Navion Service Bulletin No. 103
July 20, 2004

Subject	Airframe – Fuselage Reinforcing Kit
Effectivity	Serial Numbers NAV-4-002 thru NAV-4-2561
Purpose	Unapproved fuselage beef-up components have been discovered that fail to conform to FAA approved design data. These components, when installed as fuselage structural reinforcements for the installation of the Lycoming GO-435, Continental IO-470P, IO-470C, IO-470H & IO-520B, fail to meet strength requirements.
Compliance	Mandatory
Description	<p>The Navion Part Numbers for the unapproved parts are 145-31102-XX, 143-31001-411, 143-31001-412, 143-31001-429, 143-31001-425, 143-31001-426, 143-31102-XX, 143-31002-66, 143-31001-415, 143-31001-416, 143-31001-417, 143-31001-418, 143-31001-427, 143-31007-39, 143-31007-40, 143-31007-41. Unapproved parts can be identified by one of the following methods:</p> <ol style="list-style-type: none">1. All 145-31102-XX & 143-31102-XX fittings should be stamped out of a single piece of steel. Unapproved parts will have secondary pieces of varying size and shape welded inside the front flange near the large bolt hole. Suspect parts will also have welded joints along the edges of the same flange. Wall thi

Figure 3: Fuselage Station 93 & surrounding area

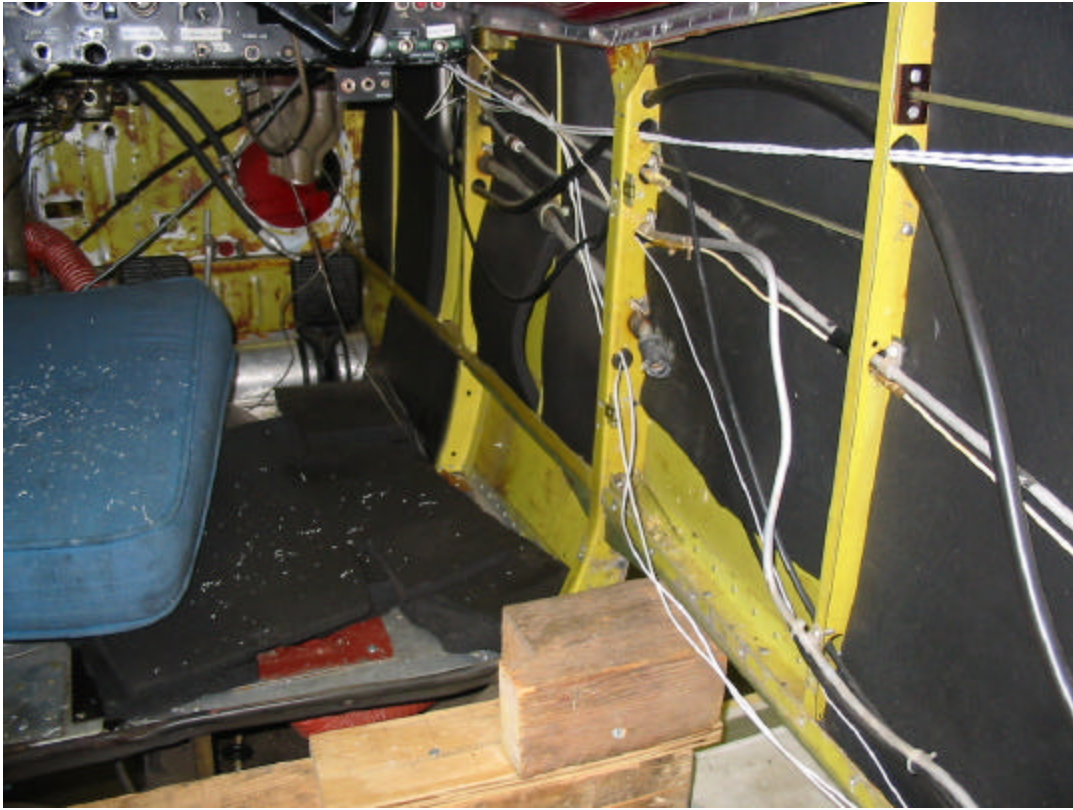
3. 143-31001-411, 143-31001-412 & 143-31001-429 upper longeron stiffeners which run in either direction from fuselage station 93 should have a thickness of 0.091 ± 0.010 inches. Any other thickness fails to meet strength requirements or conform to approved design data.
4. 143-31007-39, 143-31007-40 & 143-31007-41 Nose gear beam stiffeners should have a thickness of 0.072 ± 0.010 inches. Any other thickness fails to meet strength requirements or conform to approved design data.

If any part fails to meet strength requirements or conform to approved design data, all parts of the kit are considered unapproved and should be inspected for conformity. Kits which fail to conform must be replaced.
